Superior NW Enterprises

August 24, 2023

RE: Review of retaining wall plan for 6950 SE Maker, PN-9350900620

Figure 1. Excerpt from page C-2 of the submitted plan set. The base of the fir is roughly at the 214 grade level. Fir tree rarely if ever have roots deeper than 3' below grade. It is highly unlikely that this tree has any significant root density in the area east (right) of the existing rock wall.

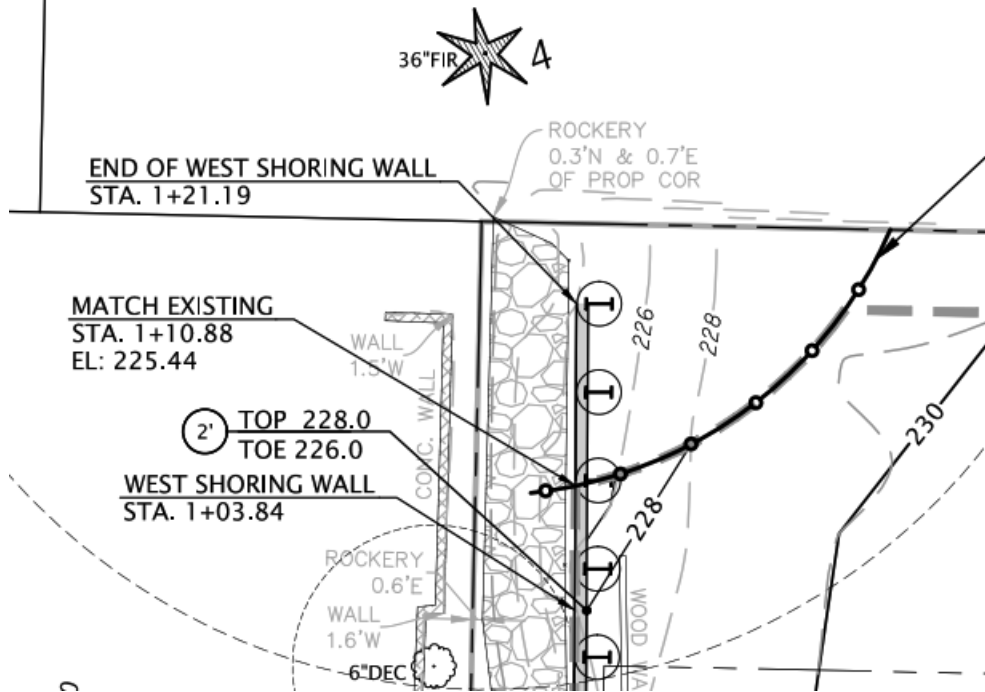
Based on the plan set drawing shown in Figure 1 the north end of the new wall will terminate 15' out from the base of the tree. This means there is no chance that the work will damage the Structural Root Plate of the tree.

The base of the #4 tree is close to 5' below the level of *the base* of the existing stone wall which ends right at the NW corner post. According to the architect and builder this wall will remain in place and not be disturbed. Only a secondary section of stone that is well outside the theoretical CRZ will be removed to facilitate the installation of the pile wall.

The work plan states that the machinery required for drilling the pile holes will be stationed outside the theoretical CRZ for the tree. This is not absolutely necessary as it is highly unlikely that the fir has any roots present east of the existing wall in the first place. Douglas fir rarely has roots present below 36" due to compaction and oxygenation constraints.

In this specific case the tree is unlikely to have pushed roots around the wall and upslope into the subject property as there is not a resource base present that would have drawn roots into the space. Drilling the line of five 24" diameter holes within the theoretical CRZ would realistically create little functional impact even if the tree did have roots present in the space. They move perpendicularly away from the tree and have exponentially lessor chances of intersecting with any roots that may present.

Installing another wall 4-5' E and nearly 5' higher on the grade will create no significant disturbance for the tree. No excavation will be done to the existing grade. There will be fill work done to level the grade but this will occur over only 6% of the tree's theoretical rooting space. Again, it is highly unlikely that the fir does have roots present in the area.

Out of an abundance of caution an arborist should be onsite during the proposed work.
